City of Fredericksburg

Historic Review Board Meeting Agenda
Tuesday, July 11, 2023 ~ 5:30 PM
Law Enforcement Center
1601 E. Main Street
Fredericksburg, Texas 78624

HISTORIC REVIEW BOARD AGENDA MEMO

CAPTION: 23-152 - **409 E. MAIN** - *WHITNEY KOCH* - ADD TWO ARBORS BEHIND EXISTING RETAIL BUILDING.

2021 request

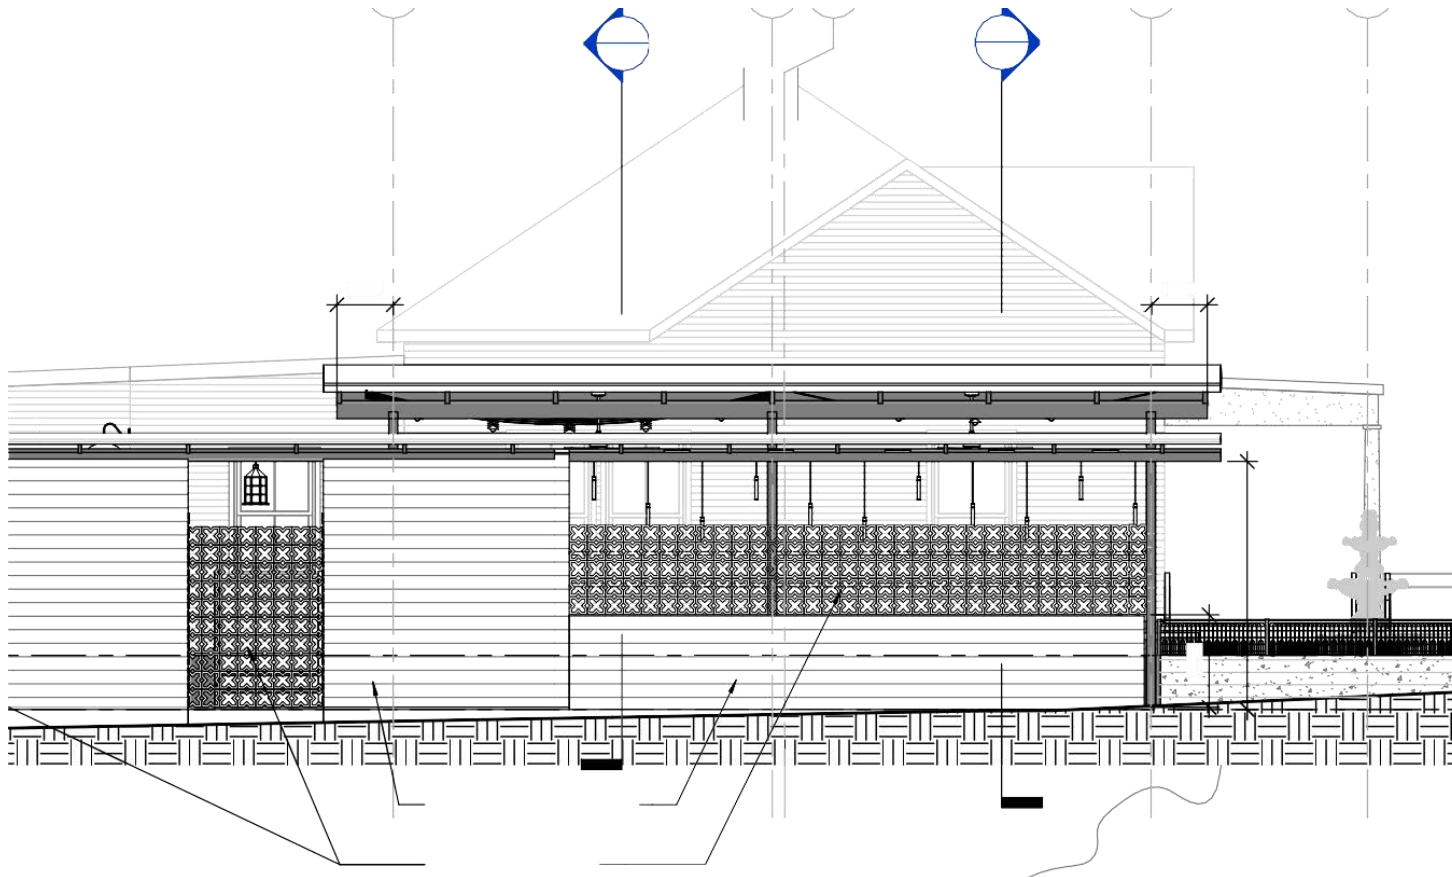
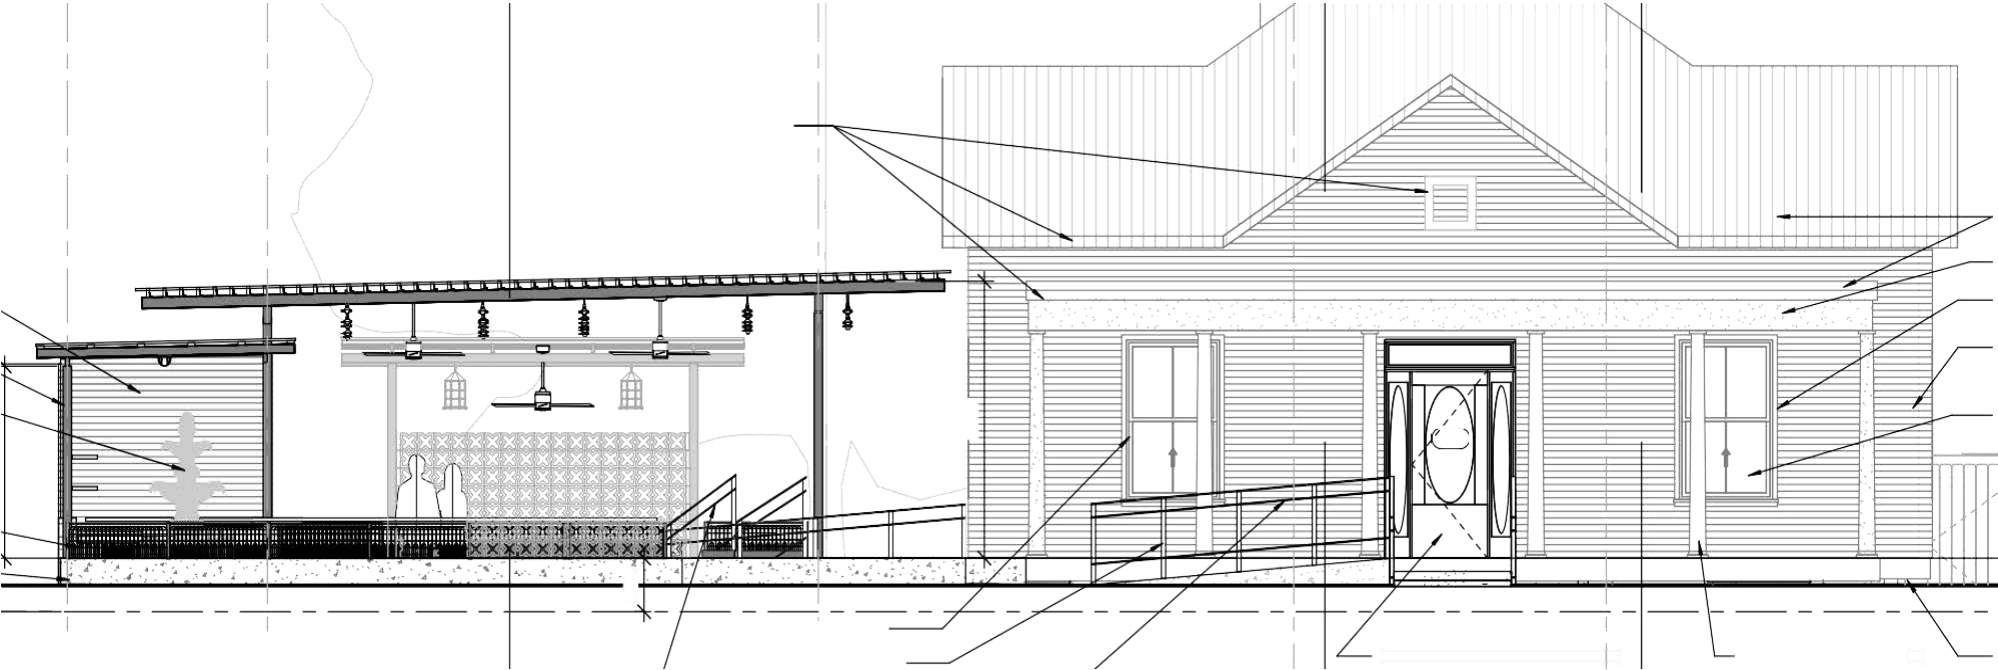
Staff recommends the new pergola/covered trellis is pulled back from the front façade. The height is compatible, and the openness of the structure is a benefit. More detail is needed on how the pergola will abut the side of the house. As presented staff does not recommend approval based on Section 3.3 a, c and e.

Approved as submitted with the exception of the decorative block on the new outdoor eating area. An alternative railing can be approved administratively.

EXTERIOR ELEVATIONS

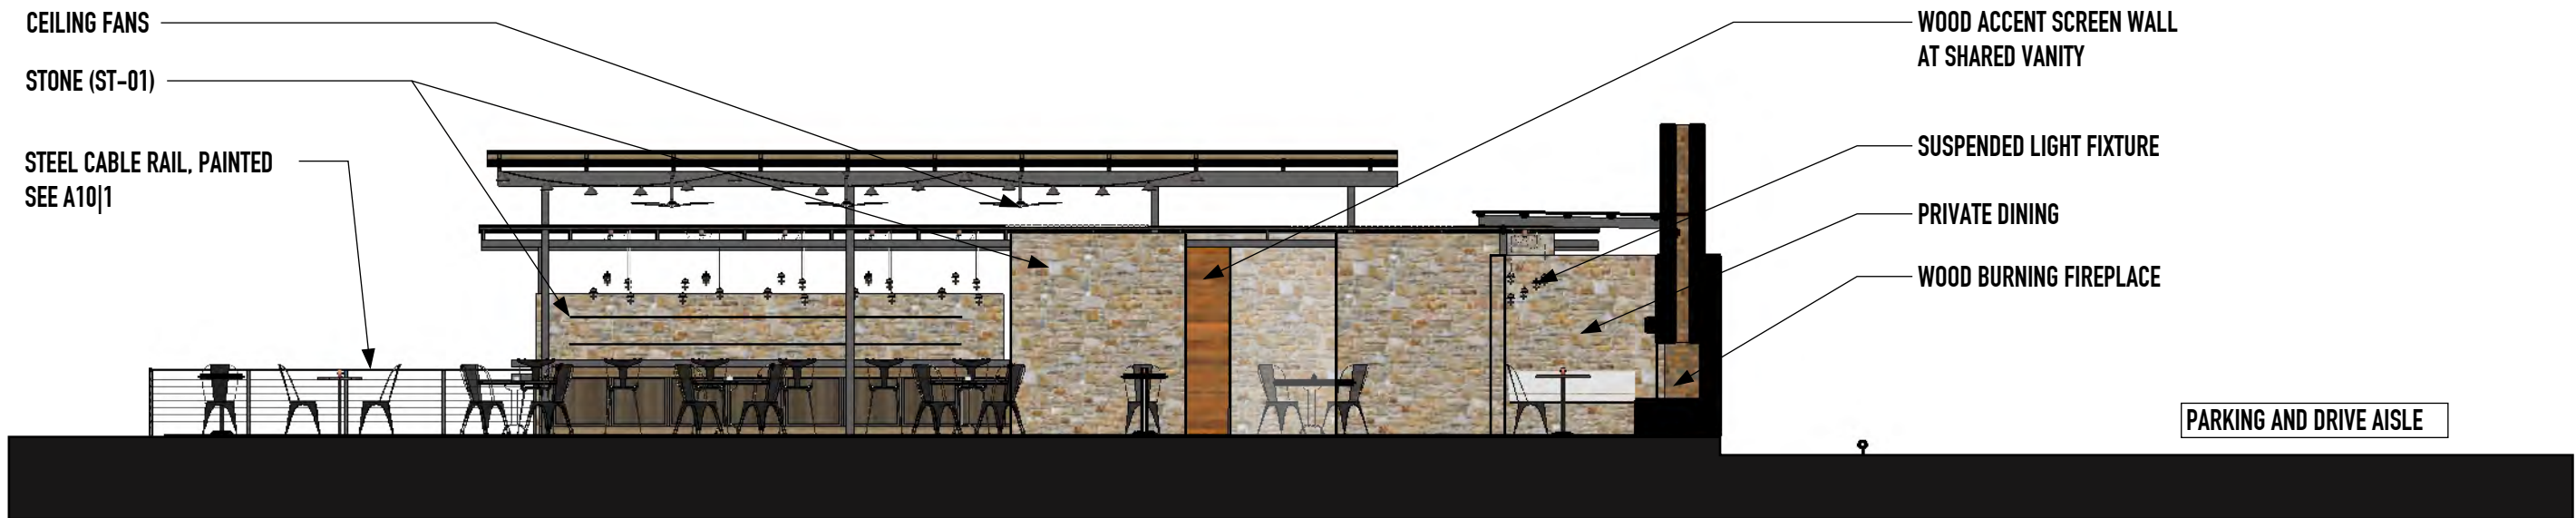
Additions are required to avoid obstructing historic character-defining features of the site and property. As proposed, the solid southern wall obstructs the view of the historic structure. In addition, Staff comments for the previous COA (2022) were to leave the openness of the outdoor space and recommended that the outdoor seating area not become an enclosed space in the future. The proposal feels like a step backward from the previous submittal.
